APPENDIX A
Notice of Preparation Comment Letters

Milligan Parking Lot Project

Subject: Milligan Parking Lot Project, Notice of Preparation of a Supplemental Draft Environmental Impact Report, SCH No. 2003042127, Santa Clara County

RE: Milligan Parking Lot Project (ER20-049) DSEIR SCOPING COMMENTS

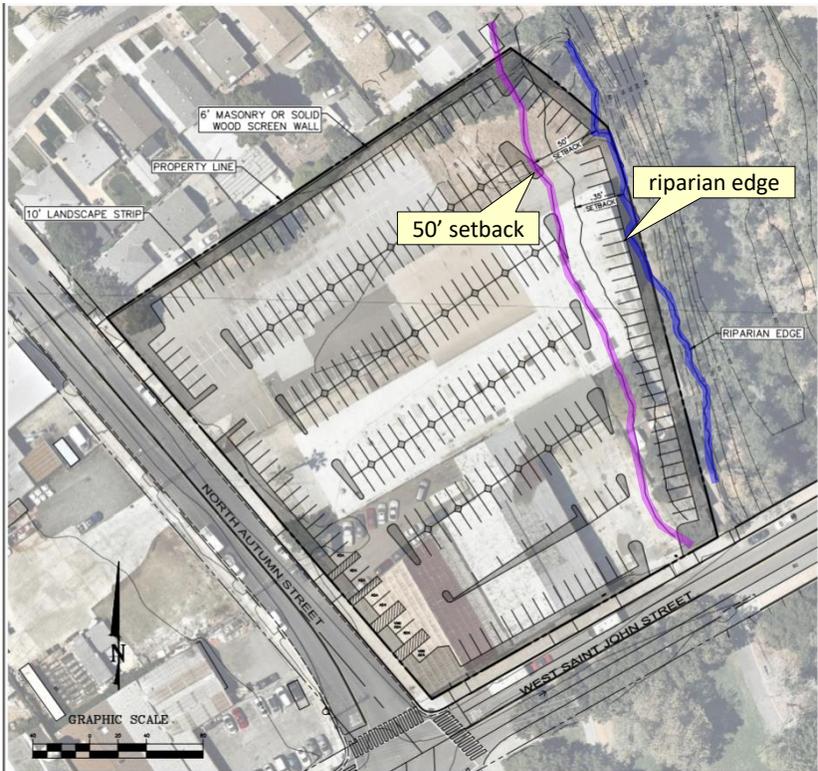
However, the project proposed here by the City violates the City’s own ordinances by not even providing the *minimally* required setbacks. Indeed, the plan even calls for a masonry or solid wood wall in places to be built *within* the riparian corridor itself.

- If the City grants itself a waiver, how can it deny any future waiver request? “Do as I say, not as I do”?
- What are the impacts of construction so close to the bank? What are the bank stabilization and flood-control issues?

- How many parking spaces could be provided if the project were designed in compliance with the City’s riparian setback policies? Does the difference between the as-proposed and this number comprise an overwhelming need that justifies the overriding of the City’s riparian policy?

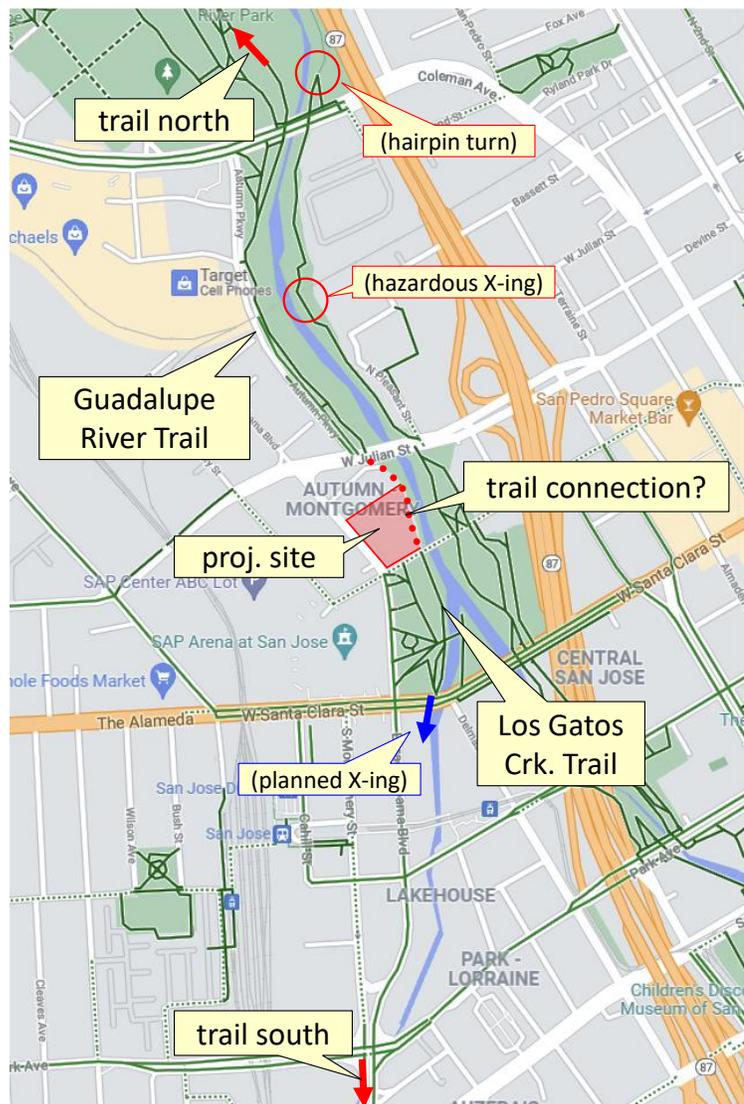
San José has a world-class trail network. The project site is the ideal location for the connection of the Los Gatos Creek Trail and the Guadalupe River Trail, as shown to the right by the dotted red line. The City, I believe, had once planned for the trail connection to be made by on-street bike lanes, but that was to have been along the no-longer-planned Autumn Parkway extension.

Note that the trail on the left-bank (west side) of the Guadalupe is the through route to the north, and the trail to the south of the project aligns with a planned overcrossing that is part of the DSAP.

- What would be the impact to the Vehicle Miles Traveled (VMT) by enabling a safe connection of two regional trails?
